Office Action Summary

10/522,210

RIU, HERVE

- 1) ☒ Responsive to communication(s) filed on 04 December 2006.
- 2a) ☒ This action is **FINAL**. 2b) ☐ This action is non-final.
- 3) ☐ Since this application is in condition for allowance except for formal matters, prosecution as to the merits is closed in accordance with the practice under *Ex parte Quayle*, 1935 C.D. 11, 453 O.G. 213.

Taken from Riu Figure 1

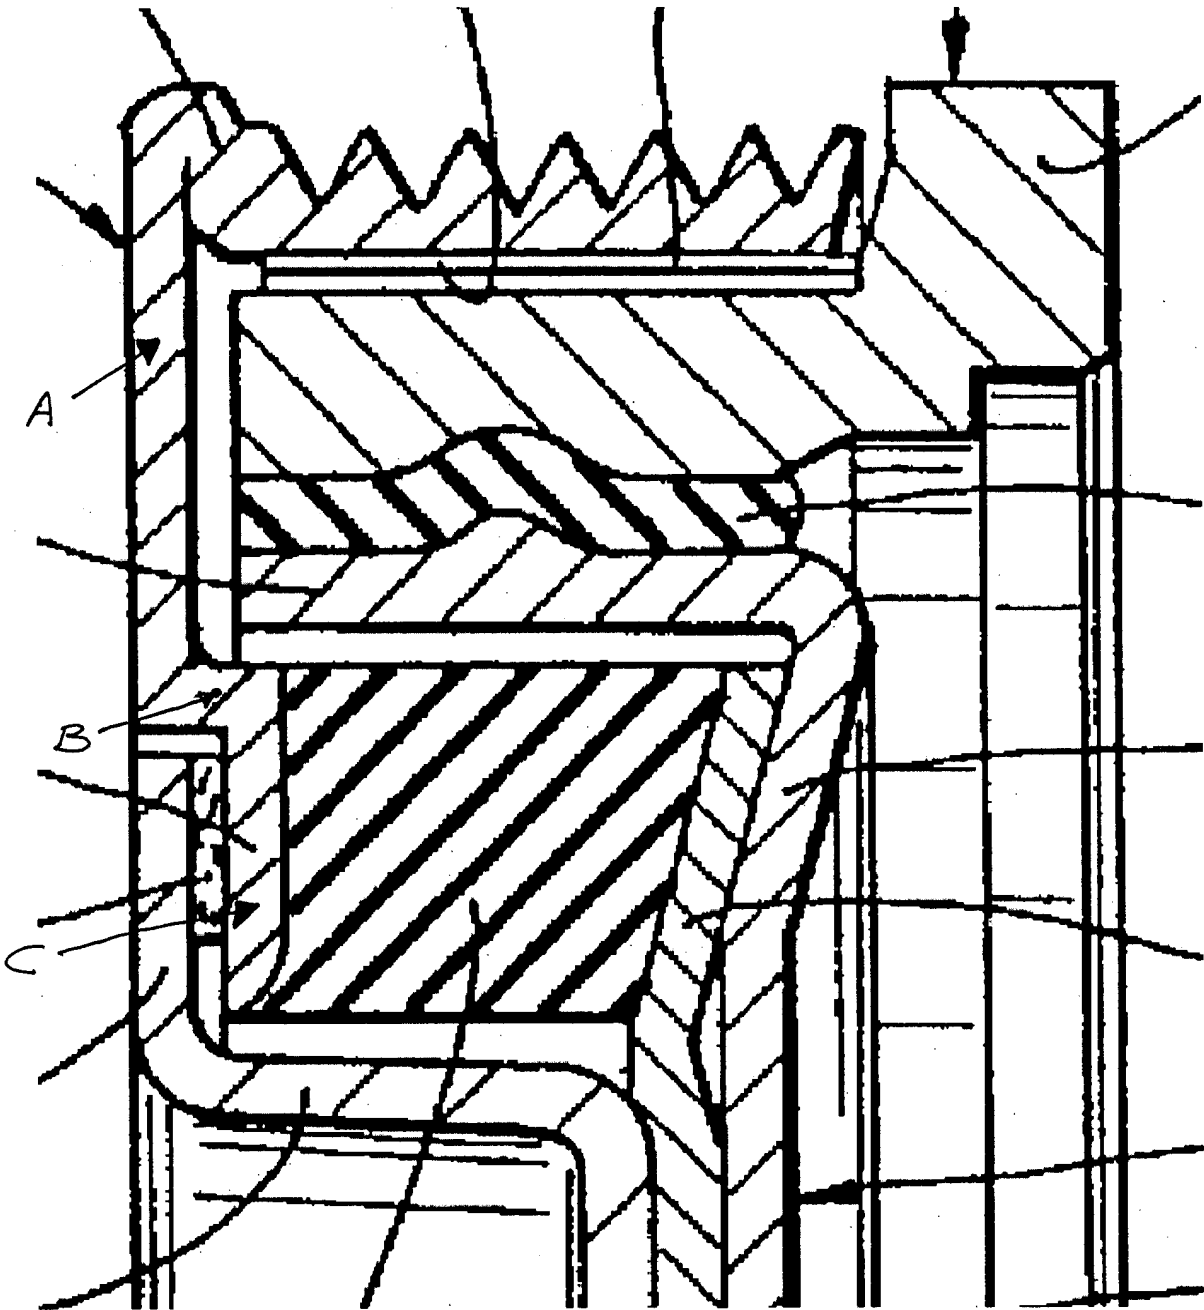
Riu discloses an integrated pulley-torsional damper assembly including:

- A hub (11)
- A drive member (at axis 20)
- A pulley (21) connected to the hub (11, via 24 and 25)
- A first elastomeric ring (24)
- A inertia ring (19)
- A second elastomeric ring (14)
- Said hub comprising:
 - An internal annular flange (16)

- An annular coupling portion (12) having a substantially C-shaped cross section
 - A cavity (houses 23, 24 and 25)
 - An outer tubular wall (13) on which said second elastomeric ring (14) is fitted

- A bearing (40) set between the outer tubular wall (13) and the pulley (21)
- Said pulley comprising:
 - A peripheral crown (22)
 - A flange (23/33) extending radially inwards from said crown (22)

- Said flange (23) comprising:
 - An outer annular portion (A, see Figure below)
 - An intermediate tubular wall (B) coaxial with respect to the crown (22)

- An inner annular flange (C) extending [radially] inward from said tubular wall (B) opposite the outer annular portion (A) and facing the peripheral edge (25) of the coupling flange (29)

- A coupling flange (29) provided with an inner annular wall (26) bearing axially against said flange (16) of the hub (11) and with a peripheral annular edge (25)

- Said first elastomeric ring (24) being set axially between said inner annular flange (C) and the peripheral annular edge (25) and forming a single body (one pulley) with them
- Said inertia ring (19) being contained inside said crown (22)
- Said elastomeric ring (24) being housed within said cavity of said annular coupling portion (12)
